## Accessibility Survey

## City of Downey Luxor Street - Patton Road To Downey Avenue

Date of Inspection  
12/9/2016

## City of Downey Luxor Street - Rives Avenue To Mitla Avenue

#### Change In Level West Of Old River School Road @ 33.942919368972, - 118.154531121254

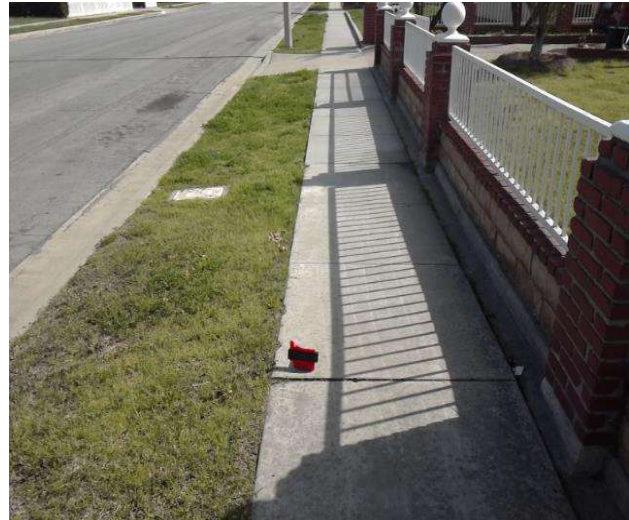
There is a change in elevation greater than recommended value.

**On-Site Finding** 0.75 inches

Ensure that the change in elevation is within the recommended value.

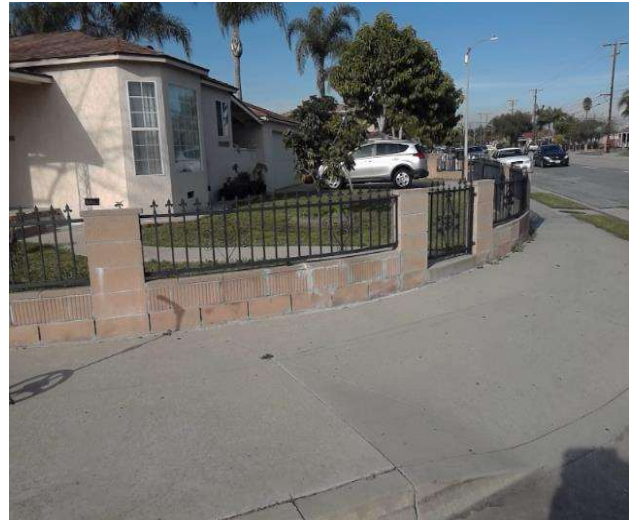
The slope of the curb ramp side flare is greater than allowed.

**On-Site Finding** 18.50 percent

Provide curb ramp side flares with a compliant slope.

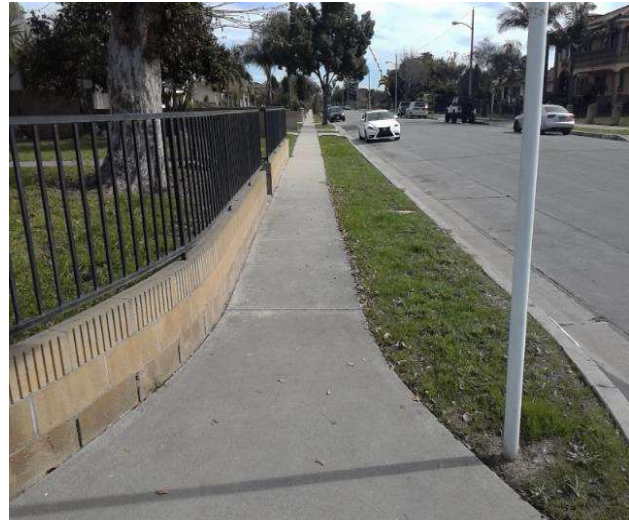
There is no 60X60 turn area at every 200 feet.

**On-Site Finding** Not Found

Provide a 60X60 turn every 200 feet on the sidewalk.

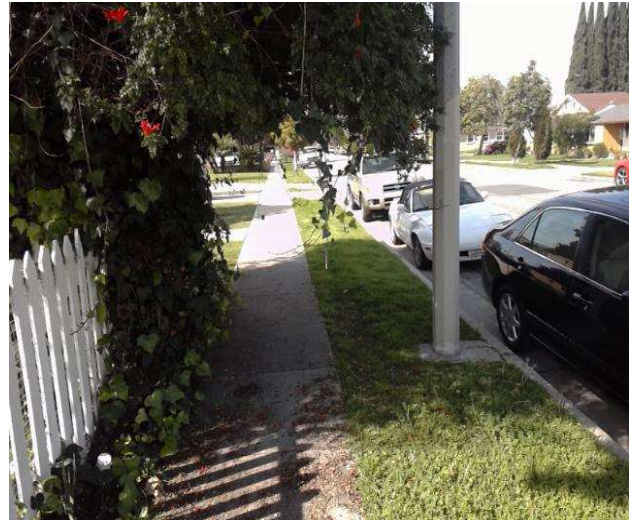
Overhead obstruction height is not compliant.

**On-Site Finding** 40.00 inches

Provide a compliant vertical clearance height.

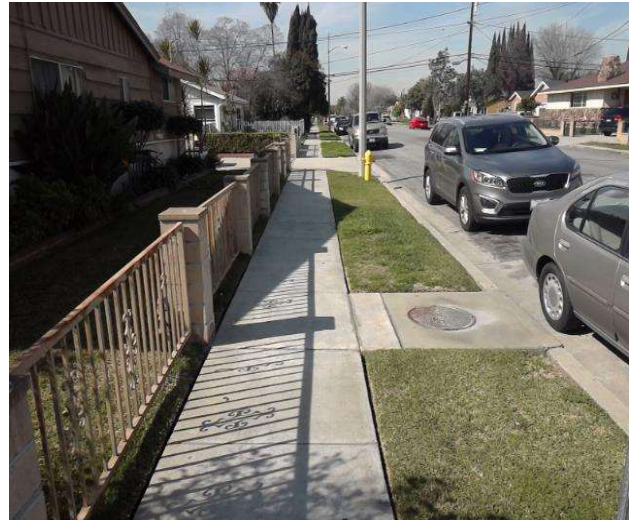
Sidewalk cross slope is not compliant.

**On-Site Finding** 3.60 percent for 41.00 feet

Repave the sidewalk surface with the recommended cross slope.

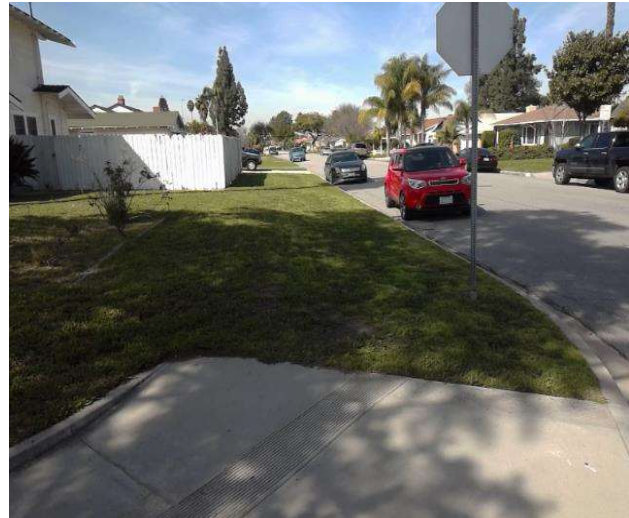
There is no 60X60 turn area at every 200 feet.

**On-Site Finding** Not Found

Provide a 60X60 turn every 200 feet on the sidewalk.
